GROUP	MODEL
Safety Recall Campaign	2015-2019MY Soul EV (PS EV)
NUMBER	DATE
SC267 (Rev 4, 05/07/2024)	August 2023

HIGH-VOLTAGE BATTERY PACK AND BATTERY MANAGEMENT SYSTEM (SC267)

This bulletin has been revised to include additional information. New/revised sections of this bulletin are indicated by a black bar in the margin area.

Flowchart and Revision Summary:

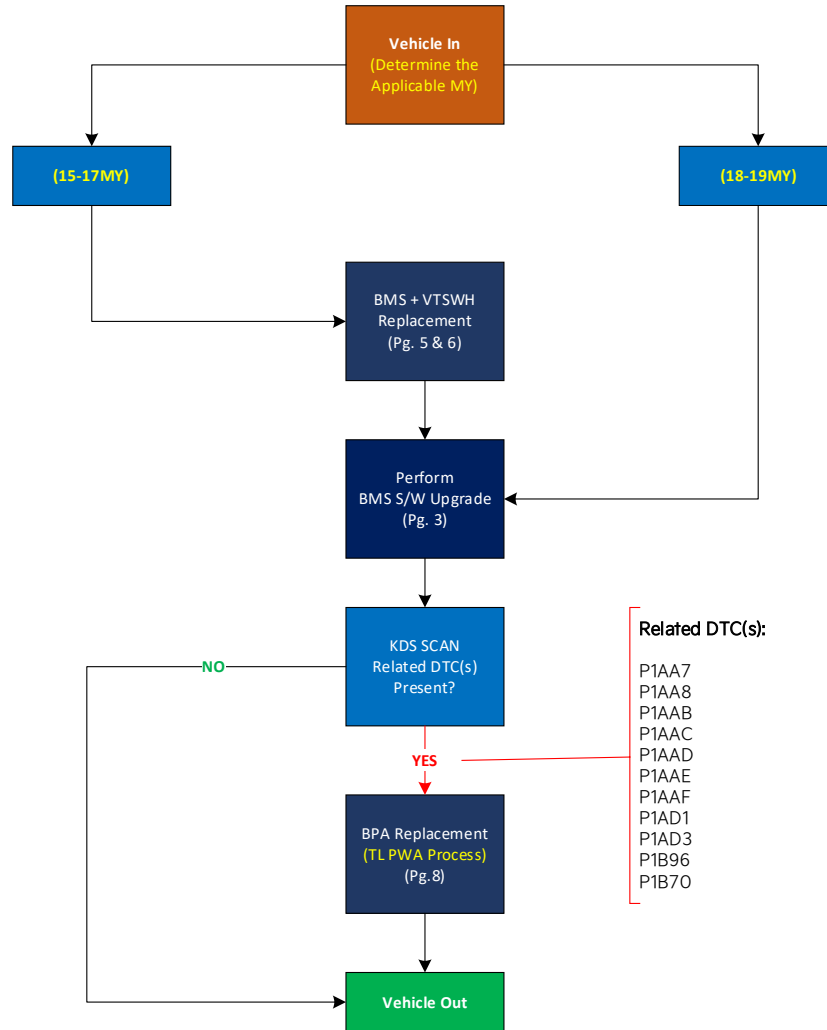
Revision 2: 'BPA Label Inspection' is no longer required and steps were removed from this publication.

Revision 3: Correction to page reference on page 5, step 3.

Revision 4: New BPA PN for 15-17MY has 'new' type harness pre-installed. New SW ROM ID updated.

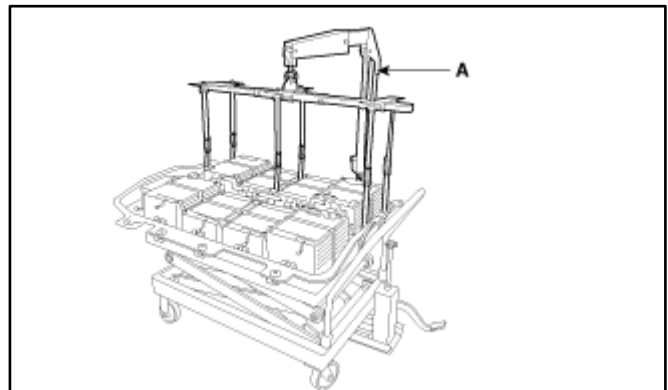
15-17MY ONLY new PN BPA is equipped with a "new" type harness. **(Rev 4) removed swap harness.**

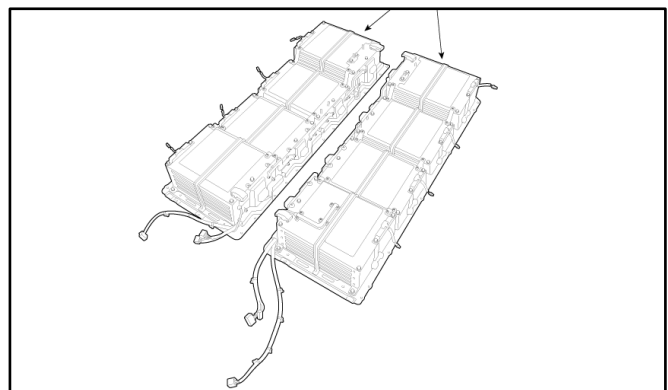
18-19MY ONLY new BPA is equipped with the "new" type harness. There is no need to swap.
